PROPOSED BROWSE TO NORTH WEST SHELF PROJECT

Environment Review Document - Response to
Submissions (EPA Assessment No. 2190)

November 2023

Figure 3-1 Annual average results from MODU NO2 modelling showing exceedances of current NEPM thresholds (red) and future NEPM thresholds (orange)

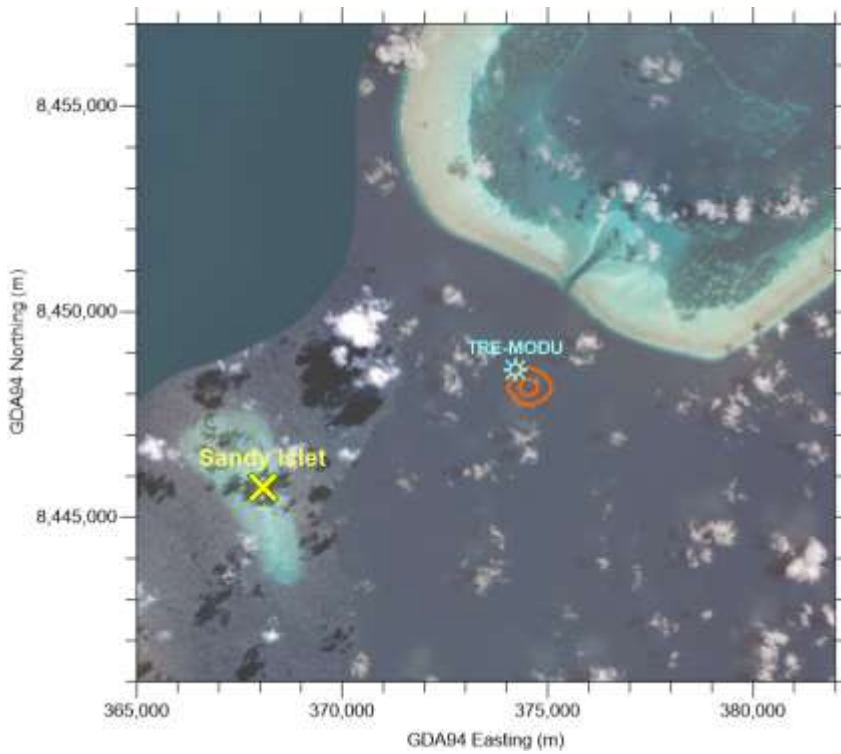
EPA comments	Proponent’s response
Factor 1: Air Quality		
1	<p>Details of a quantitative air quality assessment (modelling of NO2 emissions from routine MODU and production platform power generation for an offshore project undertaken by another operator (BP, 2013) has not been provided in the EIS/ERD to support the conclusion that risks are negligible for this component of the project.</p> <p>Provide further details to support the conclusion that the risks are negligible.</p>	<p>The BP (2013) study is considered a good analogue for the proposed Browse Project as it included consideration of two MODUs operating simultaneously, which may occur during the life of the proposed Browse Project (at different drill centres). The proposed Browse Project drilling locations are around ten times further from sensitive receptors (i.e. populated coastal areas) than the BP modelled locations.</p> <p>Further details of the BP (2013) study referenced in Section 6.3.5 the draft EIS/ERD can be found in Chapter 9 (Drilling and Completion Environmental Impact Assessment, Mitigation and Monitoring) of the publicly available “Shah Deniz 2 Project Environmental & Socio-Economic Impact Assessment”, which is available at https://www.bp.com/content/dam/bp/country-sites/en_az/azerbaijan/home/pdfs/esias/sd/sd2/9_drilling_eia.pdf</p> <p>To provide further evidence to support this description of the source of aspect, additional modelling considering local Browse meteorological conditions and MODU assumptions has been conducted to further support the impact assessment. The full modelling report is included in Error! Reference source not found..</p> <p>Modelling Scenario</p> <p>Modelling considers a scenario which has been more specifically tailored to the proposed Browse Project:</p> <ul style="list-style-type: none"> • A single MODU has been modelled at TRE (the closest location to Sandy Islet, considered to be the nearest nesting and/or roosting site for seabirds and migratory shorebirds).

EPA comments	Proponent's response
		<p>Model Results</p> <p>Modelling was conducted separately to produce average annual and 1-hr max sea-level concentration results in the ambient environment. Neither current nor future NEPM air quality standards for average annual or one-hour max results were exceeded at Sandy Islet.</p> <p>Average annual results (Figure 3-1) using the TAPM-GRS (photochemical) modelling indicate no exceedance of current NEPM air quality standards at sea level. Future NEPM air quality standards may be exceeded up to 1,025m away from the MODU.</p> <p>One hour max results (Figure 3-2) indicate an exceedance of current and future NEPM air quality standards at sea level further away (up to 7,580 m and 10,400 m from the MODU respectively), extending furthest in a southeasterly and southerly direction. It should be noted that the 1-hour modelling shows the maximum average concentration for a particular cell on the grid over any 1-hour duration in the modelling results over an entire year. Therefore, the image does not represent a single set of metocean conditions (i.e. prevailing wind direction), but rather the metocean conditions that achieve the highest concentration at each individual grid cell.</p> <p>Discussion</p> <p>As discussed within Section 5.3.2.4.1 of the draft EIS/ERD, seabirds around Scott Reef are predominately associated with Sandy Islet, a part of South Scott Reef, and occur in small numbers in comparison to other breeding and roosting sites in the region. Smith et al. (2004) recorded little tern (500 individuals), brown booby (6), ruddy turnstone (50), Australian lesser noddy (200) and the common noddy (30) during a survey at Scott Reef in 2003. Seabird surveys conducted at Scott Reef observed greater numbers of birds during spring than winter (Jenner et al., 2009). Seabird species typically roost on Sandy Islet at night and are presumed to forage in nearby and offshore waters during the day. It is not currently known if any of the observed species are permanently resident on Sandy Islet.</p> <p>The environmental impact assessment for air emissions from offshore activities in the draft EIS/ERD (Section 6.3.5.3) identified that: <i>Atmospheric emissions from the proposed Browse Project have the potential to result in a localized reduction in air quality in the immediate vicinity of the release point. While a slight reduction in air quality on a local scale will occur for the duration of the activities, given the low</i></p>

EPA comments	Proponent's response
		<p><i>emissions levels, very low background levels of pollutants and distance from the emissions sources to the nearest environmental sensitive receptors, it is not anticipated that emissions from the proposed Browse to NWS Project will result in lasting effect on air quality locally or regionally.</i></p> <p>Given that the results of NO₂ modelling indicate that NEPM air quality standards are not expected to be exceeded at Sandy Islet, the results of the modelling provide further confidence in the environmental impact assessment presented in the draft EIS/ERD. It is also noted that the TRE drill centre is no longer proposed. It should also be noted that MODU campaigns are of limited duration, and that therefore the above results are inherently conservative. No lasting impact to seabirds and migratory shorebirds as a result of atmospheric emissions is expected. As such, monitoring of bird species present within the Scott Reef complex to assess the potential impacts and risks to seabirds and migratory bird species resulting from air emissions from the proposed Browse Project is not considered warranted.</p>
